CITY OF ALBUQUERQUE

August 23, 2022

RE: **Lot 6 Block 1 Volcano Cliffs Unit 22 SAD 228**
8019 Alto Rey Ct. NW
Grading and Drainage Plan
Engineers Stamp Date 7/23/2020 (D10D003N6)
Pad Certification Date 8/19/2022

ENGINEER'S SEAL 7/23/20 DAVID SOULE P.E. #14522	LOT 6 BLK 1 UN 22 VC 8019 ALTO REY CT.	DRAWN BY DEM
	GRADING AND DRAINAGE PLAN	DATE 7-23-20
	 1606 CENTRAL AVENUE SE SUITE 201 ALBUQUERQUE, NM 87106 (505) 872-0999	LOT XX BLK 1 UN 22 VC.DWG SHEET # C1 JOB #

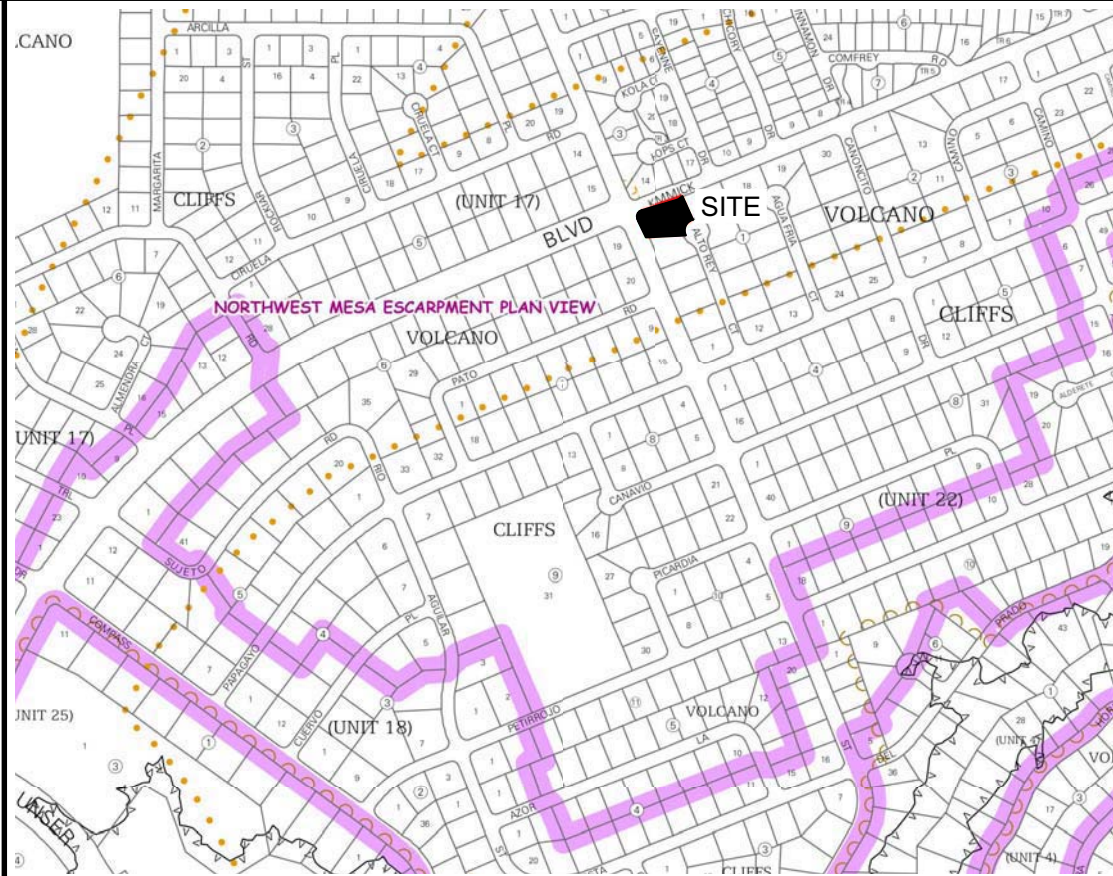
- The building pad is 4 feet to high. I believe this was addressed at grading permit. It is not allowed for a retaining wall of this height to be in the front yard. A complaint was issued on this property several months ago.

Reiterate to the Owner/Contractor that a separate permit for a garden/retaining wall must be obtained, with the approved G&D plan and Pad Certification. Advise the owner & Contractor that dirt is not allowed in the public right of way to climb the curb. Crusher fines or lumber is allowed. If dirt is used this will delay going forward with the construction of the home.
